STAFF RECOMMENDATION 2105 9th Avenue South May 17, 2017

Application: New construction—addition
District: Waverly-Belmont Neighborhood Conservation Zoning Overlay
Council District: 07
Map and Parcel Number: 10513030300
Applicant: Julie Warwick
Project Lead: Melissa Baldock, melissa.baldock@nashville.gov

Description of Project: Application is to construct a rear addition.

ELEVATIONS
SCALE: 1/8" = 1'-0"

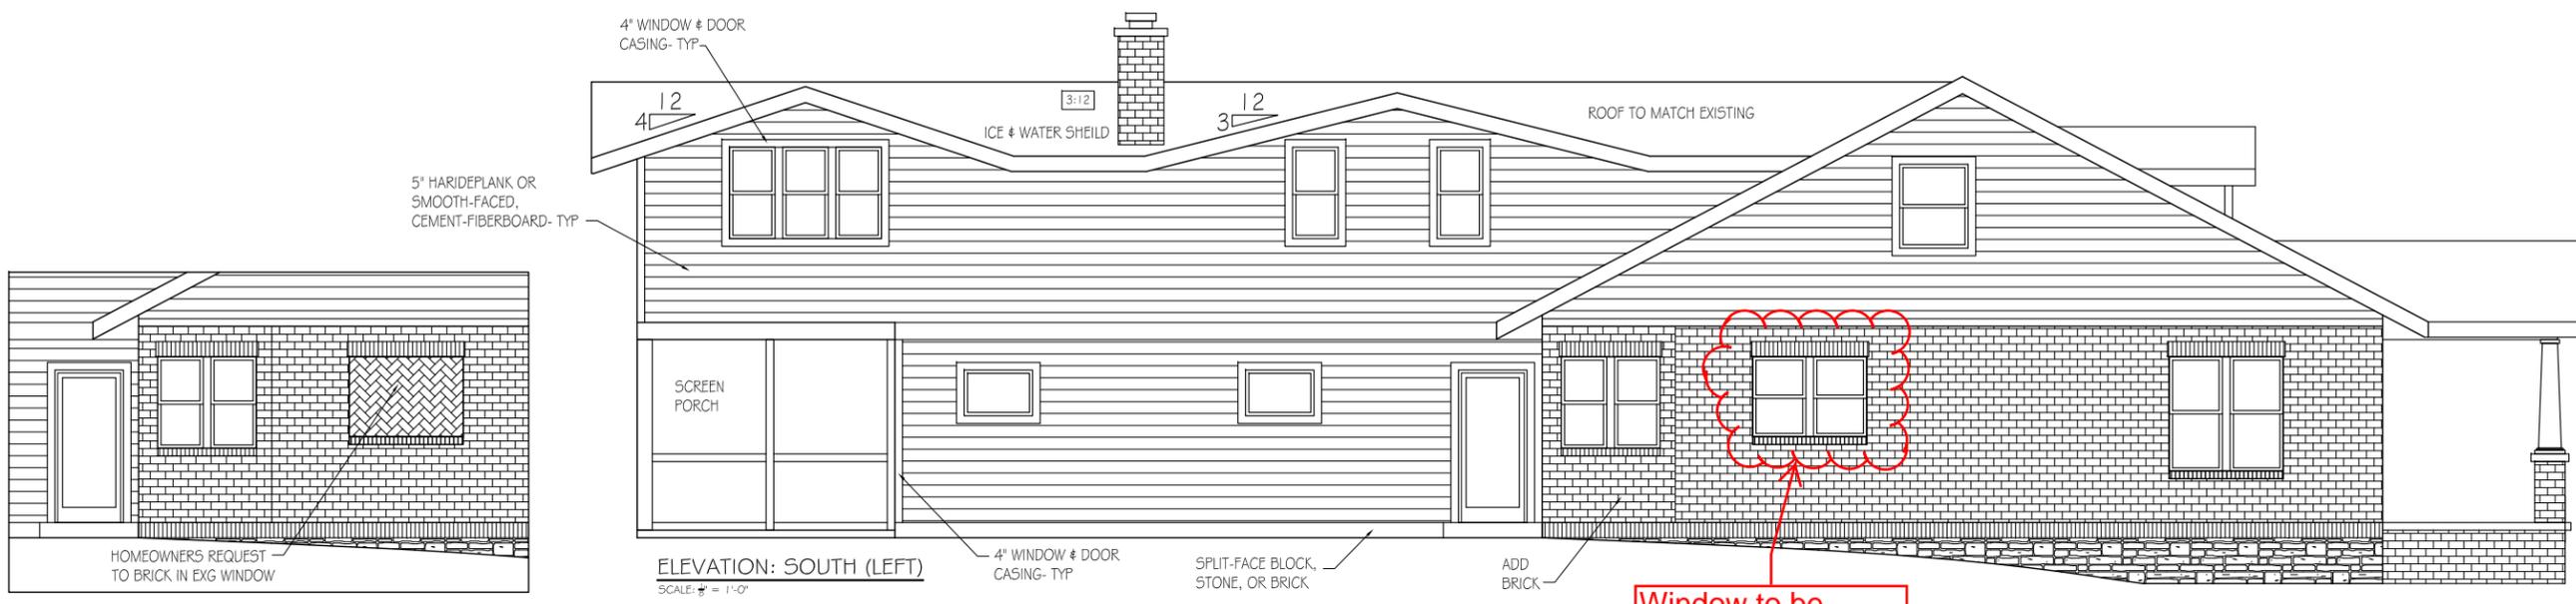
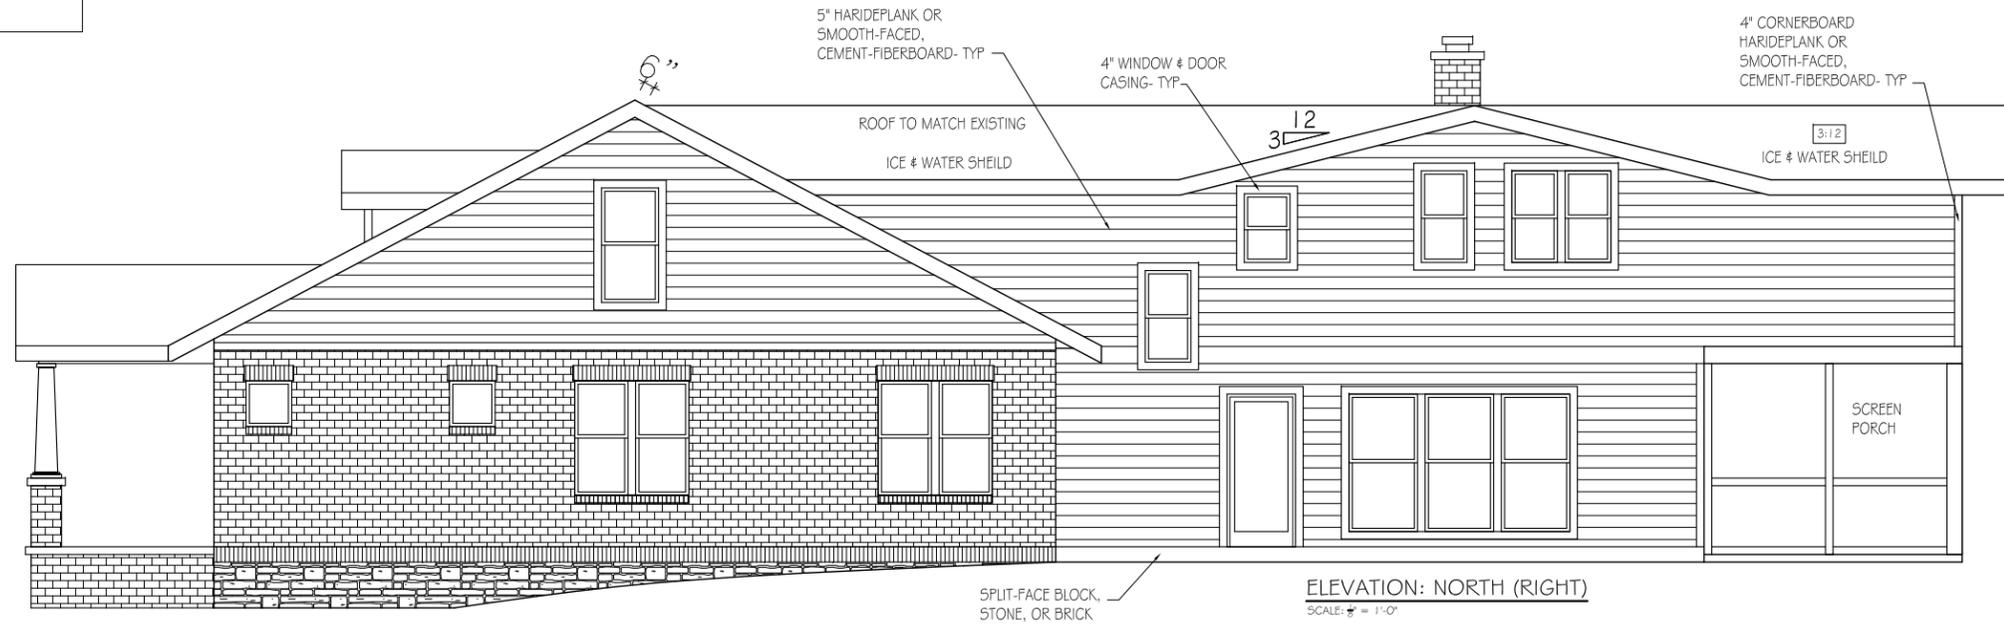
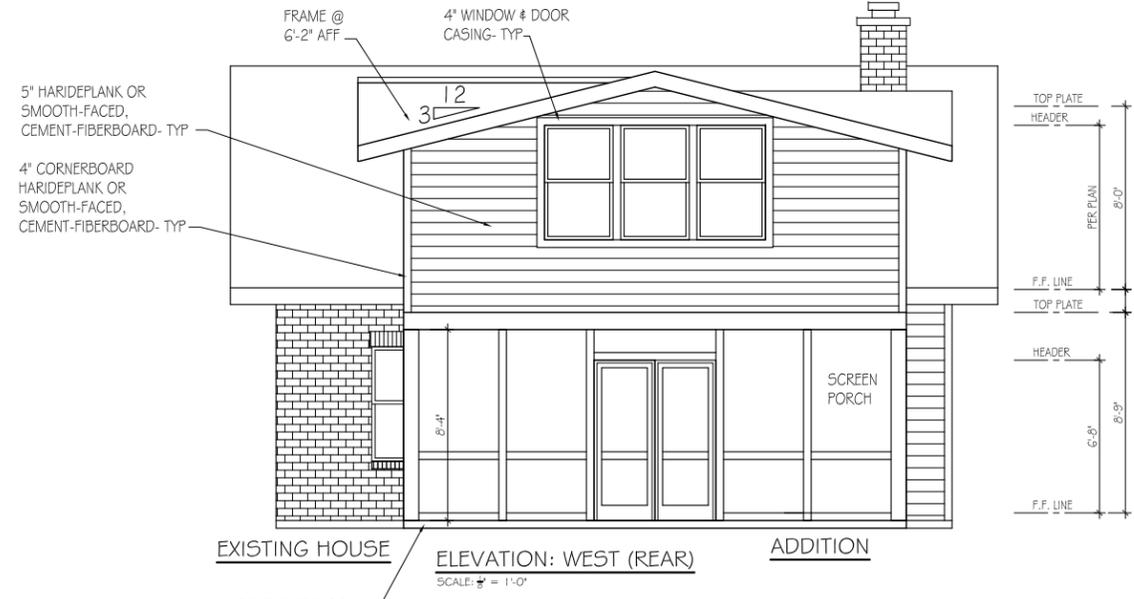
Height & Scale: The proposed addition will be inset two feet, four inches (2'4") on the left side and five feet, three inches (5'3") on the right side. The addition will be twenty-two feet (22') wide and will have a footprint of approximately eight hundred and seventy-three square feet (873 sq. ft.). This is less than historic house's footprint, which is one thousand and ninety square feet (1,090 sq. ft.).

The historic house is one and a half stories. Even though the addition will be six inches (6") lower in height than the historic house, it will be two stories in height. Its foundation height will match that of the historic house, but its eave height will be sixteen feet (16') tall (the historic house has an eave height that is nine feet, six inches (9'6") tall). Staff finds the proposed two-story addition behind the historic one-and-a-half story house to be appropriate in this instance because the addition is inset appropriately and the overall footprint of the addition is modest. Also, this historic house is significantly smaller than both the historic houses to its left and the new development to its right. Figures 2 and 3 show that the larger two-story development surrounding 2105 9th Avenue South dwarfs the twenty-two foot (22') tall historic house. Because of the surrounding context, staff finds that the proposed two-story addition, which is no taller than the historic house, meets the design guidelines.

Roof form: The historic house has a side gable roof form with a slope of 5.5/12. The proposed addition will have a gabled form with a slope of 3/12. The design guidelines state that additions should have a minimum roof slope of 6/12. Staff finds the proposed lower slope to be appropriate in this instance for a couple of reasons. The historic house's roof slope of less than 6/12 is lower than is typical for historic side gable houses in the historic neighborhood. Typical side gable houses in the area have roof slopes ranging from 7/12 to 12/12. It therefore is appropriate that the addition should have a shallower roof slope than is typically allowed in the design guidelines. In addition, as mentioned under "Height and Scale" the surrounding two-story new infill dwarfs this smaller historic house. A shallower roof slope that allows for a two-story addition is appropriate because it will not be highly visible from the street and because of the taller context. Staff finds that the proposed roof form meets Sections III.E. and IV. of the design guidelines.

Proportion and Rhythm of Openings: The proposed changes to the historic house's fenestration pattern are described under "Partial Demolition." The windows on the proposed addition are all generally twice as tall as they are wide, thereby meeting the historic proportions of openings. There are two windows on the left elevation that are horizontal, three feet wide by two feet tall (3' X 2'). Because the addition is inset, and these windows are located over forty-six feet (46') from the front wall of the house, they will not be highly visible. Staff therefore finds them to be appropriate. There are no large expanses of wall space without a window or door opening. Staff finds the project's proportion and rhythm of openings to meet Sections III.G. and IV. of the design guidelines.

Appurtenances & Utilities: No changes to the site's appurtenances were indicated on the drawings. The location of the HVAC and other utilities was also not noted. Staff asks that the HVAC be located on the rear façade, or on a side façade beyond the midpoint of the house.

1. Staff approve the final details, dimensions and materials of windows and doors prior to purchase and installation; and,
2. The HVAC shall be located behind the house or on either side, beyond the midpoint of the house.
